To G. G. Draper
From Tom Roche
Date November 21, 1974
Subject Revision to Vent System at VCM Loading Dock.
Design No. 15-700-1174-TPR

REVISION TO DOCK VENT SYSTEM

FIGURE 1

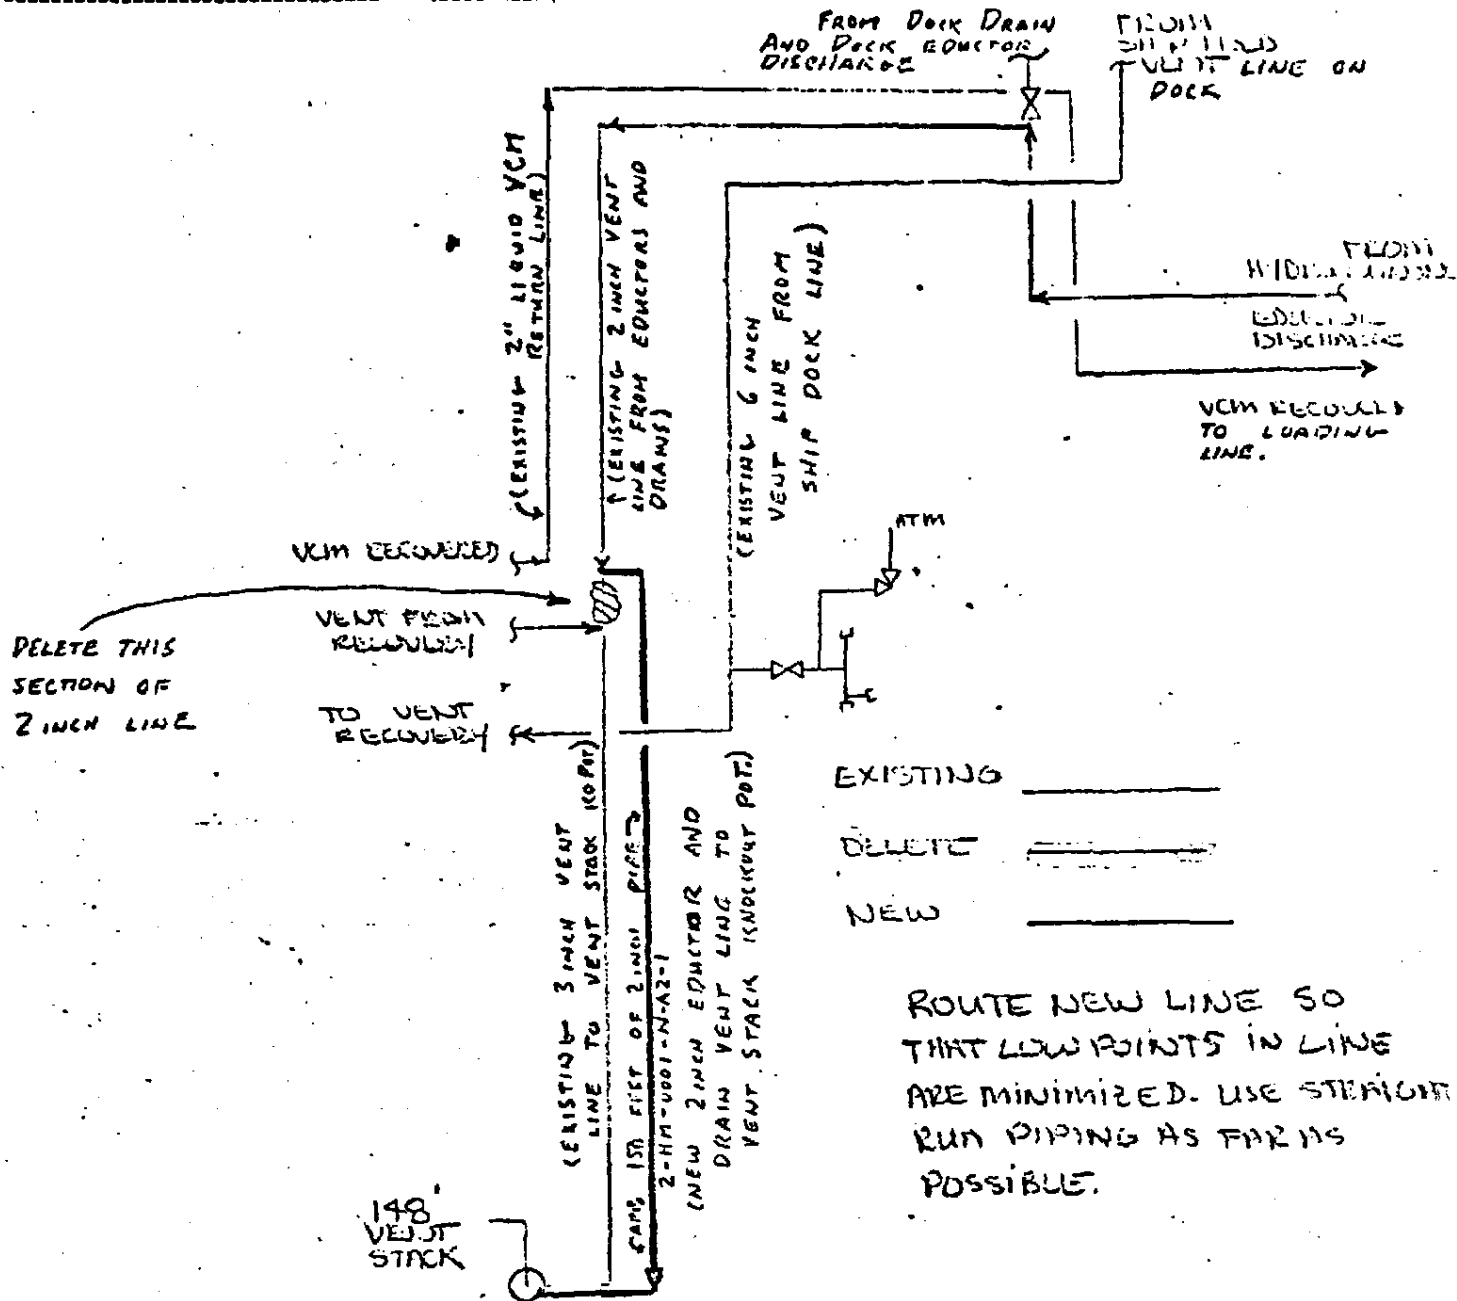
Venting from the ship increases the back pressure on the vacuum eductors on the dock and on the hydroquinone addition system. This reduces the eductor efficiency to the point where adequate vacuum can not be produced. Eductor design information indicates a 2 psig back pressure reduces the amount of vacuum produced by 30%. As a result it becomes necessary to stop the venting from the ship during hold sampling and hydroquinone addition so that these eductors will function properly. Consequently, ship loading is stopped or reduced during hydroquinone addition and hold sampling.

This design proposes to route the discharge lines from the two eductors directly to the knock-out pot located prior to the vent stack. This will reduce the back pressure effect now encountered when ship venting is in progress. Currently the discharge line from the eductors combine with the ship vent line immediately after the vent recovery system. Back pressure as a result of the pressure drop in the 3" combined vent line to the stack will be avoided by piping the eductor discharge gases to the knock-out pot separately. Approximately 150 ft. of 2" pipe will be needed.

A 2" flange connection will be needed on the KO pot to connect the new line. It should be located at approximately the same elevation as the present vent line connection to the KO pot.

ROUTE NEW LINE SO THAT LOW POINTS IN LINE ARE MINIMIZED. USE STRAIGHT RUN PIPING AS FAR AS POSSIBLE.

NOTE: A NEW 2 INCH NOZZLE WILL BE REQUIRED AT THE INLET TO THE VENT K.O. POT. THE LOCATION OF THIS NOZZLE IS NOT CRITICAL BUT IT SHOULD BE AT LEAST 3 FEET ABOVE THE BOTTOM TANGENT LINE OF THE K.O. POT.
